**15-DAY EXPRESS TERMS
FOR
PROPOSED BUILDING STANDARDS
OF THE
DIVISION OF THE STATE ARCHITECT (DSA-AC)

REGARDING THE CALIFORNIA BUILDING CODE
CALIFORNIA CODE OF REGULATIONS, TITLE 24, PART 2

2013 CALIFORNIA BUILDING CODE**

Figure 11B-404.2.4.1
Maneuvering Clearances at Manual Swinging Doors and Gates

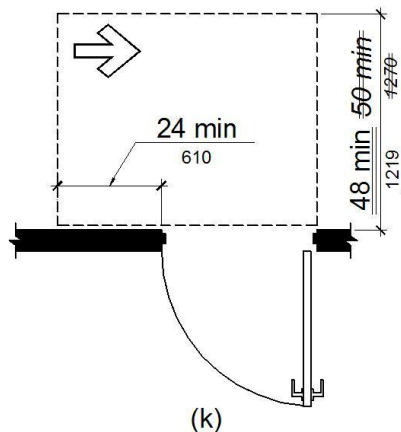
RATIONALE: DSA-AC is proposing an amendment to this figure to correct an inadvertent inconsistency between the figure and the corresponding table. Figure 11B-404.2.4.1(k) is being revised to show a 48" maneuvering clearance perpendicular to the doorway, reflecting the regulatory language of Table 11B-404.2.4.1.

Figure 11B-404.2.4.3
Maneuvering Clearances at Recessed Doors and Gates

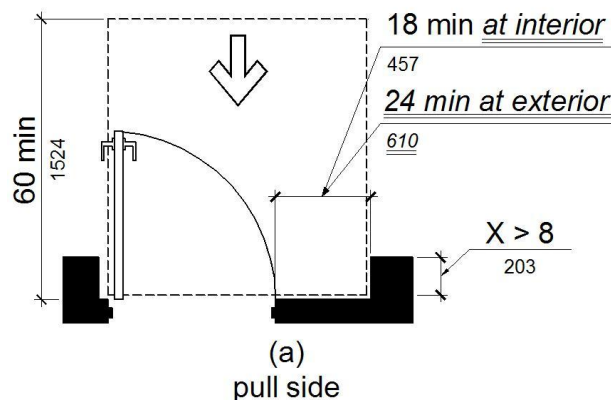
RATIONALE: DSA-AC received public comment stating that the language of this section is not consistent with the 2010 CBC, Sections 11B-1133B.2.4.2 and 1133B.2.4.5. The current CBC requirements provide an 18 inch maneuvering clearance at interior doors and a 24 inch maneuvering clearance at exterior doors. DSA-AC is proposing to amend 11B-404.2.4.3 and Figure 11B-404.2.4.3 to maintain the higher level of accessibility currently provided by the 2010 CBC.

Figure 11B-404.2.6
Doors in Series and Gates in Series

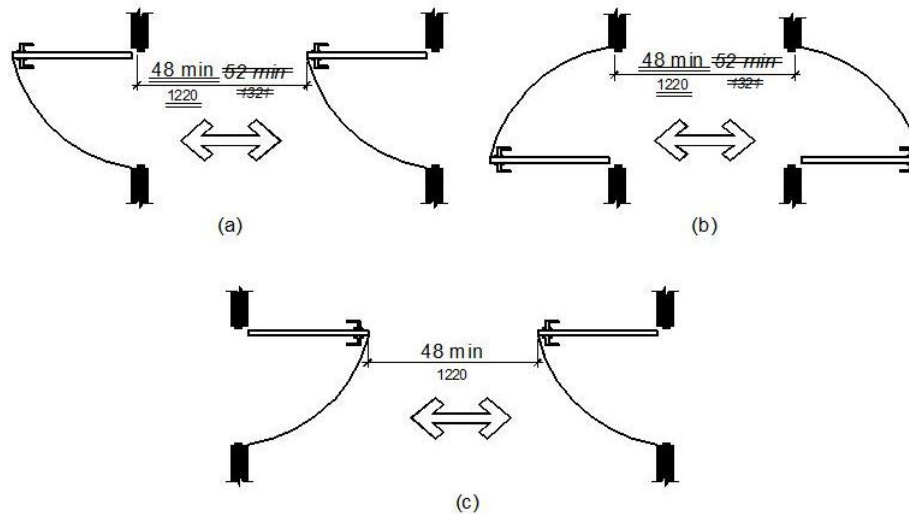
RATIONALE: DSA-AC is proposing an amendment to these figures to correct inadvertent inconsistencies between the figure and the corresponding text. Figures 11B-404.2.6 (a) & (b) are being revised to show a 48" maneuvering clearance at doors or gates in series, reflecting the regulatory language of 11B-404.2.6.

Figure 11B-607.2
Clearance for Bathtubs

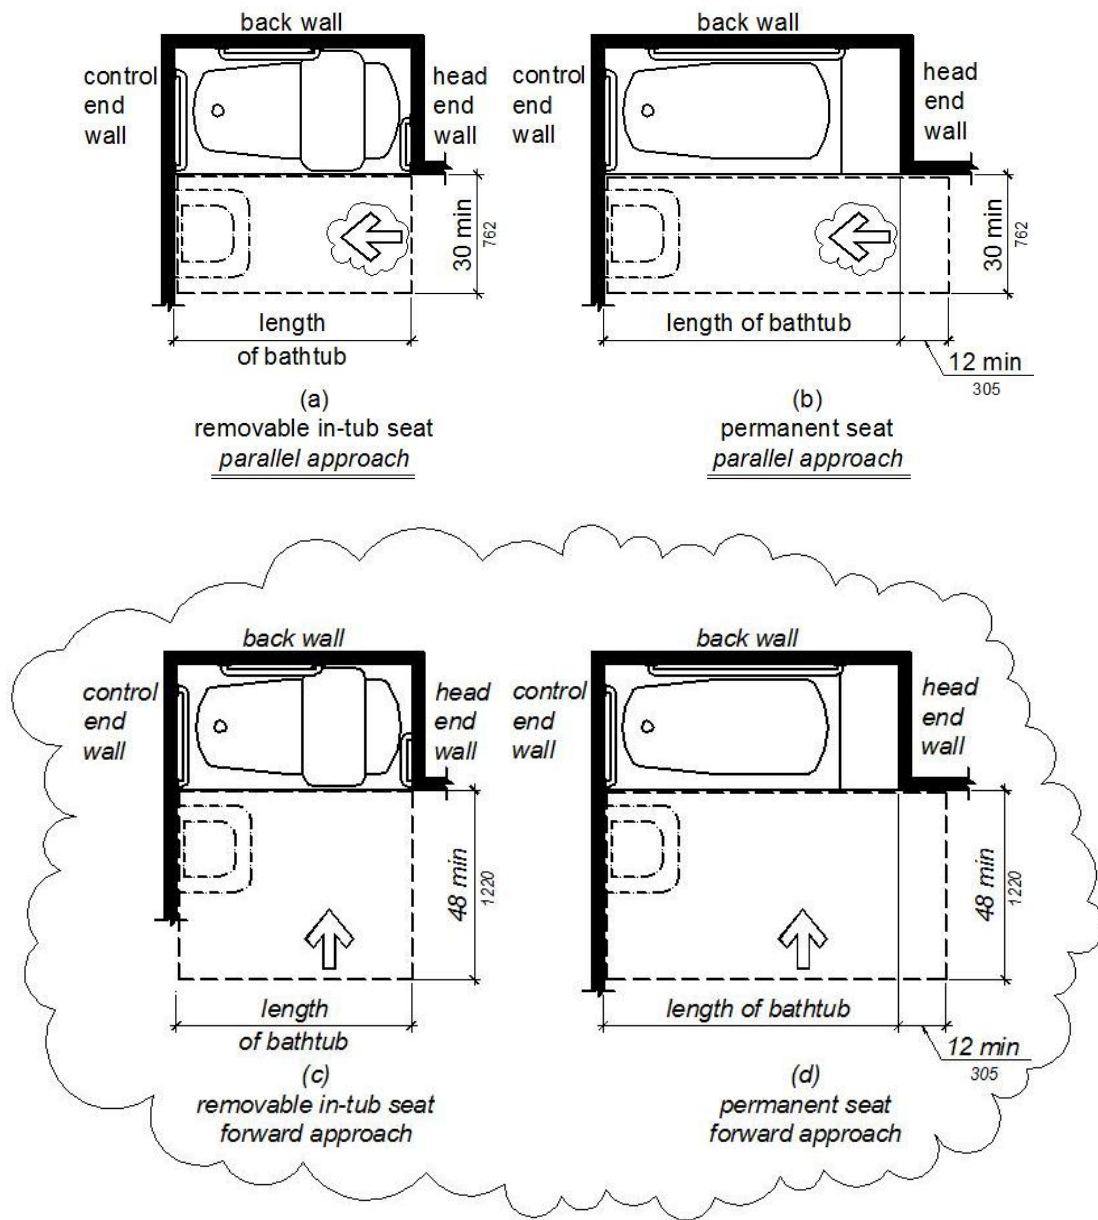
RATIONALE: DSA-AC is proposing to amend Figure 11B-607.2 to illustrate the clearance requirements for both forward and parallel approach consistent with the amendments proposed in the 45-day comment period. Diagrams (a) and (b) will be revised to include directional arrows indicating a parallel approach to the bathtubs. New diagrams (c) and (d) will be added indicating 48" wide minimum clearances and a forward approach to the bathtubs.
